Luensmann Offsite Water Main Ext PH1
Solicitation Number: CO-00717
Job No.: 23-1043

ADDENDUM 1
11/16/2023

LEGEND

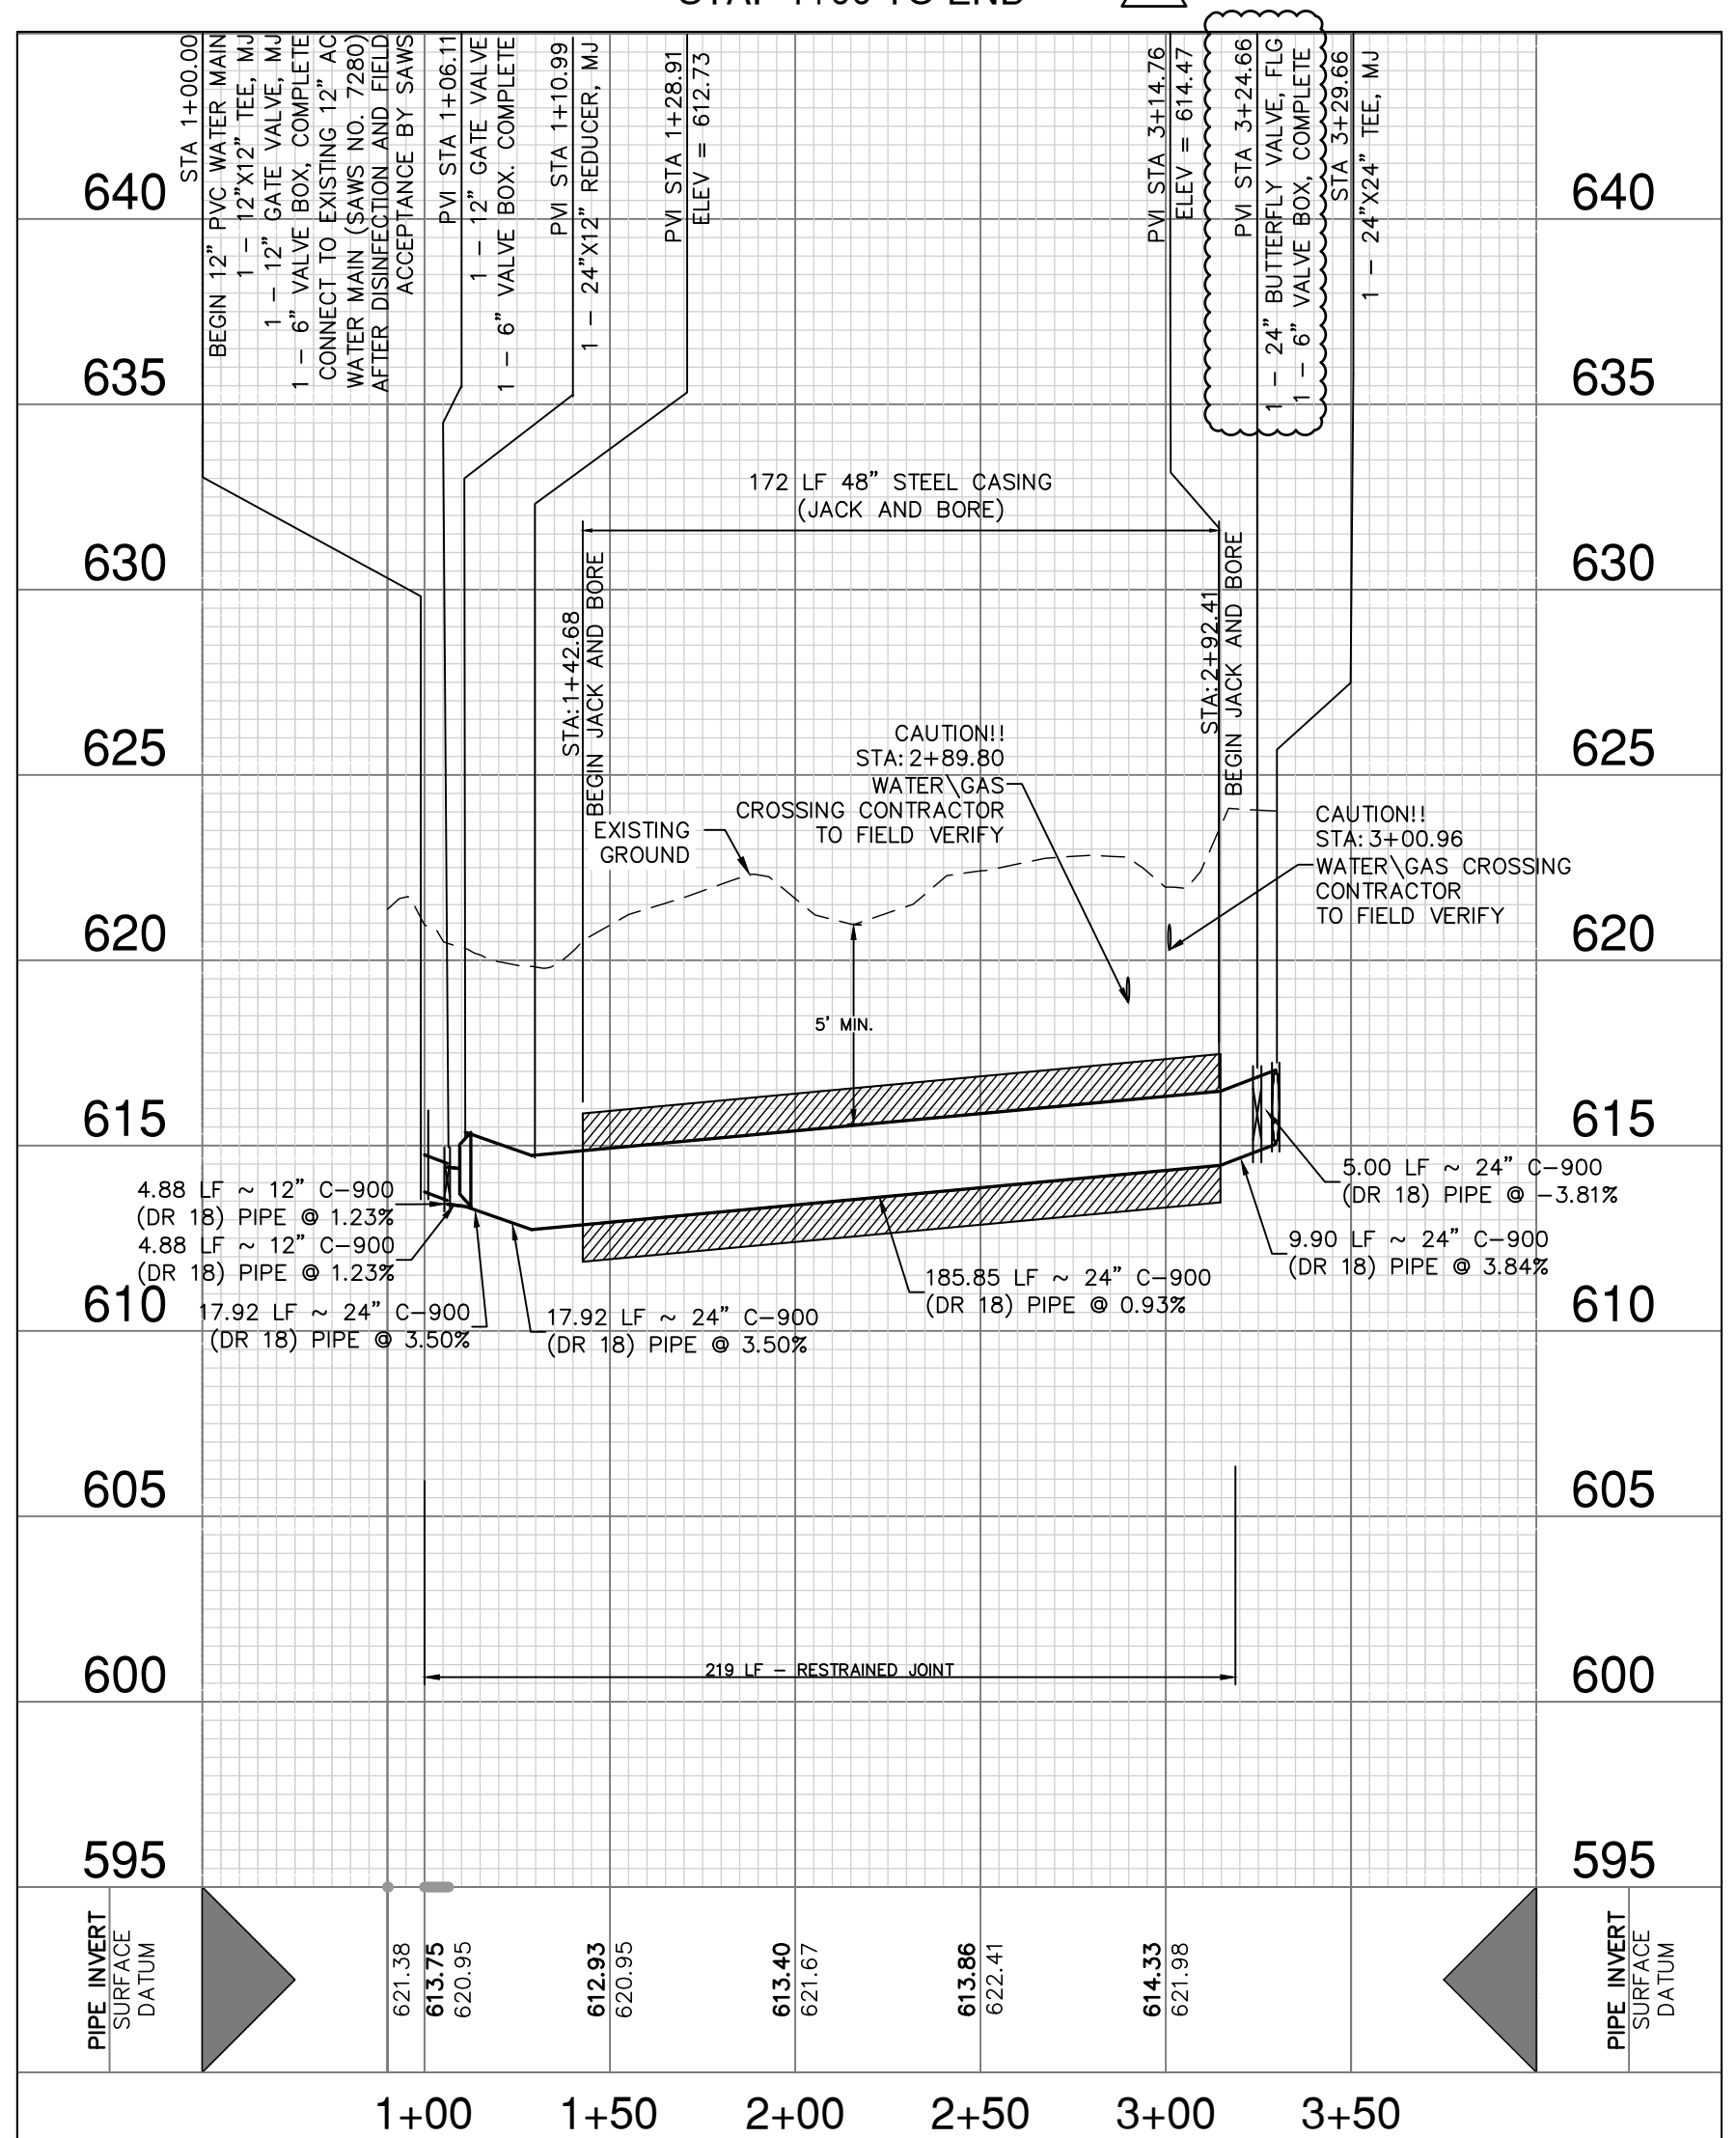
15. **Question:** Bid item 1 – Repair of Concrete Pavement (Full Depth) (TxDOT Spec) has a quantity of 76 CY per the Bid Form. Should that be 76 SY as the quantity on sheet C3.14 shows 76 SY on the quantity table?

- Updated quantity table to add a Fence Gate Type 1 and Remove and Replace Existing Fence
 - Revised 24" Butterfly valve to be Flanged.
17. Sheet C3.14: Water Main Plan and Profile Sta 151+00 to 154+00 – Remove in its entirety and replace with the attached document.
- Updated quantity table to add a Fence Gate Type 1 and Remove and Replace Existing Fence
 - Revised 24" Butterfly valve to be Flanged.

Response: See Changes to the Specifications #1. The quantity for that line item is now "SY."
